**Re: Pacific Gas & Electric's Gateway Generating Station  
License Petition Amendment (00-AFC-1C)**

# **Pacific Gas and Electric's Gateway Generating Station License Petition Amendment**

Prepared for  
**California Energy Commission**

December 2006

**FIGURE 1-1**  
**SITE ARRANGEMENT**  
PG&E GATEWAY GENERATING STATION  
CONTRA COSTA, CALIFORNIA

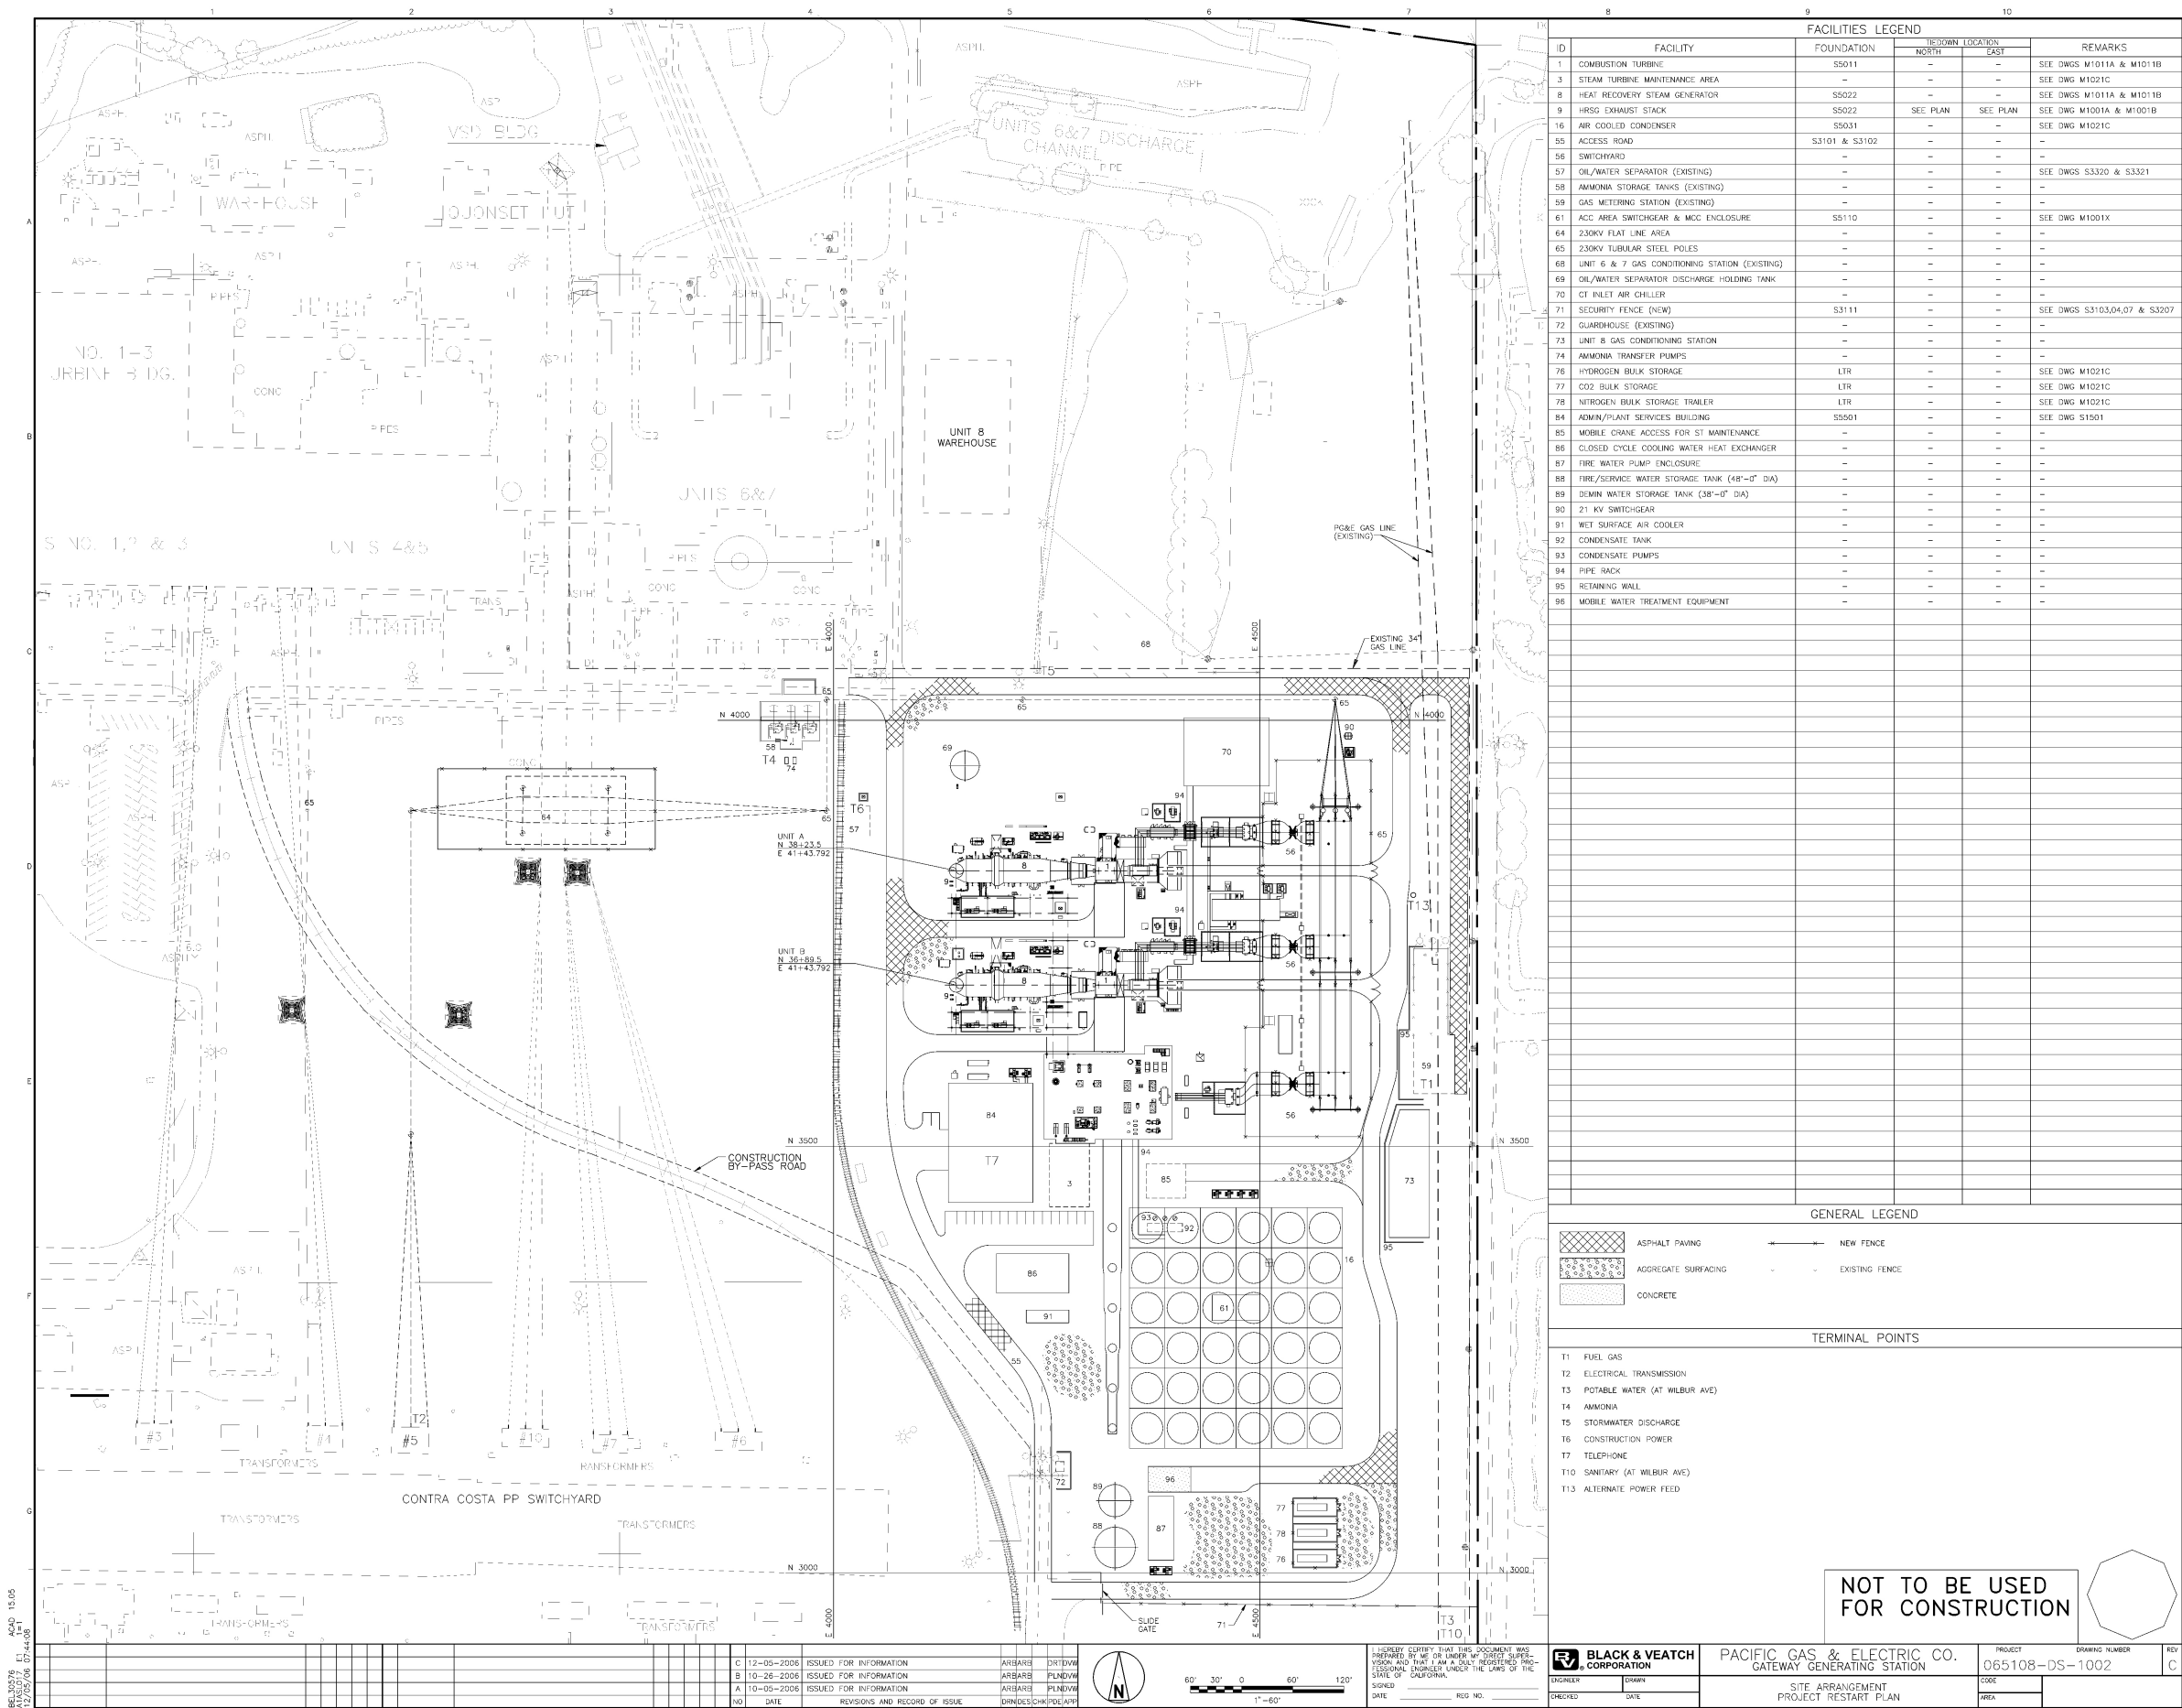
- Eliminate the use of San Joaquin River water as the cooling water source
- Replace the wet cooling tower system with a dry cooled (air cooled condenser) system
- Relocate various project facilities
- Change the combustion turbine inlet evaporative cooling system to a chilled water system
- Eliminate the use of steam power augmentation
- Include a redesigned closed cycle cooling water system

Figure 1-1 presents a revised general arrangement plan for the Gateway project based on the project design changes listed above. The remainder of this Petition to Amend the original CC8 License presents a detailed project description (Section 2), environmental analysis of the proposed project changes (Section 3), proposed modifications to the Conditions of Certification (Section 4), potential effects on the public (Section 5), a list of property owners potentially impacted by the proposed changes (Section 6), and potential effects on the property owners (Section 7).

Elimination of the wet cooling tower requires a redesign of the closed cycle cooling water system. The closed cycle cooling Water system is independent from the ACC and is a much smaller closed loop system that provides cooling water to various equipment. PG&E has determined that a fin-fan heat exchanger, in combination with a small wet surface air cooled (WSAC) heat exchanger system or usage of an evaporative precooling system will be used to provide the necessary heat rejection capacity. The proposed fin-fan system is similar to the ACC system. The WSAC system is a hybrid between a wet cooling tower and fin-fan heat exchanger, that uses water sprayed over the heat transfer bundles to increase cooling capacity of the system. The WSAC is expected to operate when ambient temperatures are high, or when additional cooling capacity is required beyond the capacity of the fin-fan heat exchanger or evaporative precooling systems. These new Gateway project features are shown on Figure 1-1.
